The amendment revises the Technical Specifications in respect to power distribution limits consequent upon extended burn up for fuel supplied by Exxon Nuclear Company.

KEWAUNEE NUCLEAR PLANT

Amendment No. 36
License No. DPR-43

SAFETY EVALUATION BY THE OFFICE OF NUCLEAR REACTOR REGULATION
RELATED TO AMENDMENT NO. 36 TO FACILITY OPERATING LICENSE NO. DPR-43

Figure TS 3.10-7

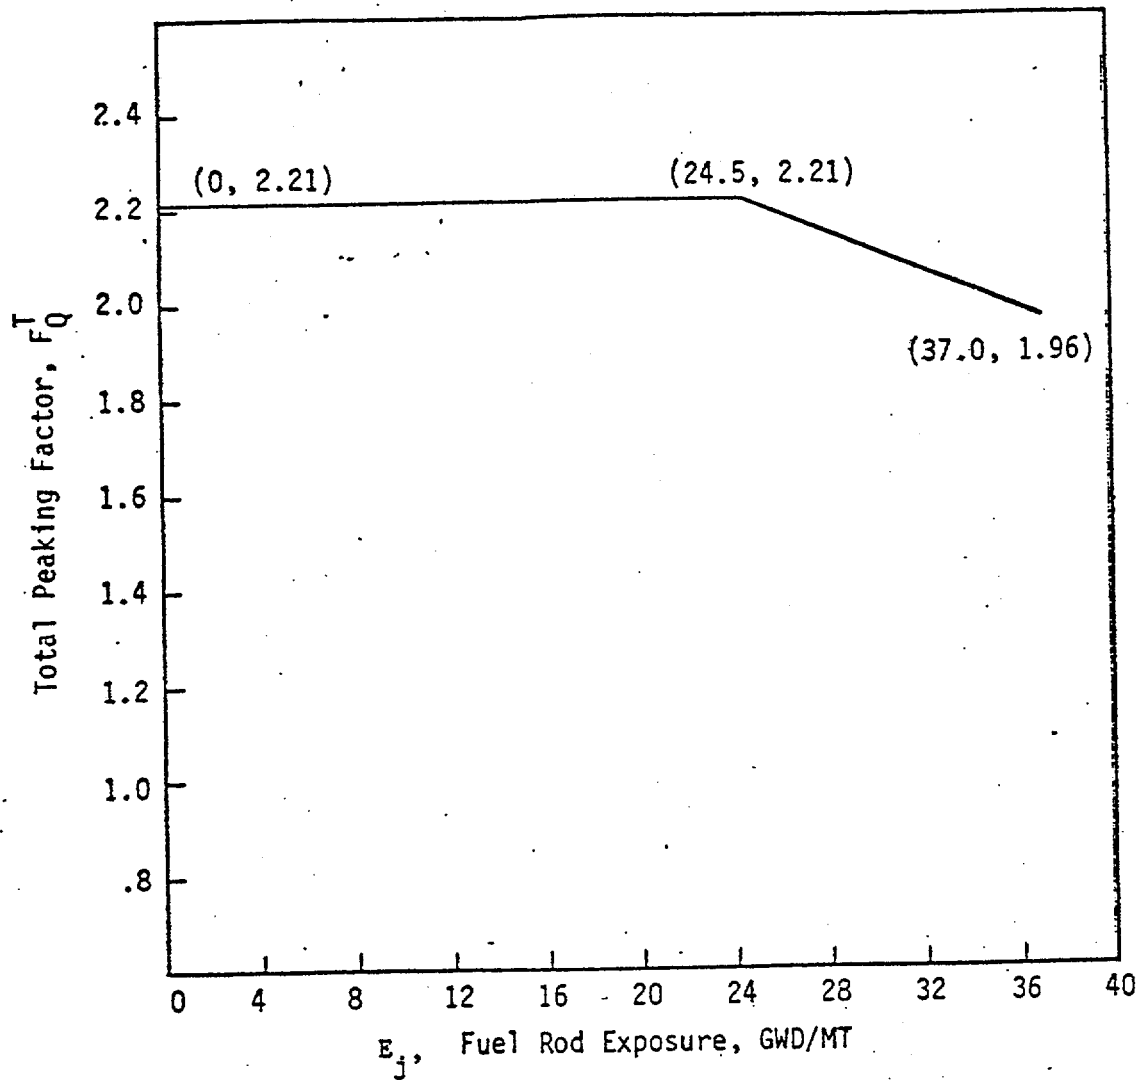
The $F_Q(Z)$ limits of specification 3.10.b.1.a include consideration of enhanced fission gas release at high burn up, off-gassing (release of sorbed gases), and other effects in fuel supplied by Exxon Nuclear Company; this results in

an additional penalty in the form of the function $BU(E_j)$, as shown in Figure TS 3.10-7, which is applied to Exxon fuel. References 7 and 8 discuss these phenomena.

Pages T. S. 3.10-10a and Figure T. S. 3.10-7 of Proposed Amendment No. 46 of the Kewaunee Technical Specifications provide an exposure dependent total peaking factor (F_0) limit for Exxon fuel to account for the effects of burn up (or fuel exposure) on internal pressure in the fuel rods. This exposure dependency is based on an Exxon exposure sensitivity study (Ref. 3) provided as part of the Kewaunee submittal. The study includes the use of an NRC-high burn up fission gas release correction term (Ref. 4) and the resulting F_0 limit remains bounded by an earlier study (Ref. 5) using clad swelling and rupture models in NUREG-0630 (Ref. 6).

$$F_Q(Z) \leq P_Q^T (E_j) \times K(Z) \text{ for } P > .5$$

$F_Q^T(E_j)$ is the function given in Figure TS 3.10-7

We have reviewed the analytical processes described in the topical report and have concluded that the assumptions and procedures followed in determining the allowable F_0 over the core life proposed are acceptable. We have concluded that operation of the Kewaunee Nuclear Power Plant with the allowable F_0 determined in the study will not result in compromising the requirements of 10 CFR 50.46 in the event of a LOCA, and that the LOCA and burn up dependent analyses have been performed in accordance with interim methodology that is acceptable.

The proposed amendment to the Technical Specifications is acceptable. The related bases which were proposed have been clarified to more generally describe all the effects influencing internal gas pressure at extended burn up; by subsequent telephone conversation, the licensee, has agreed to this clarification.
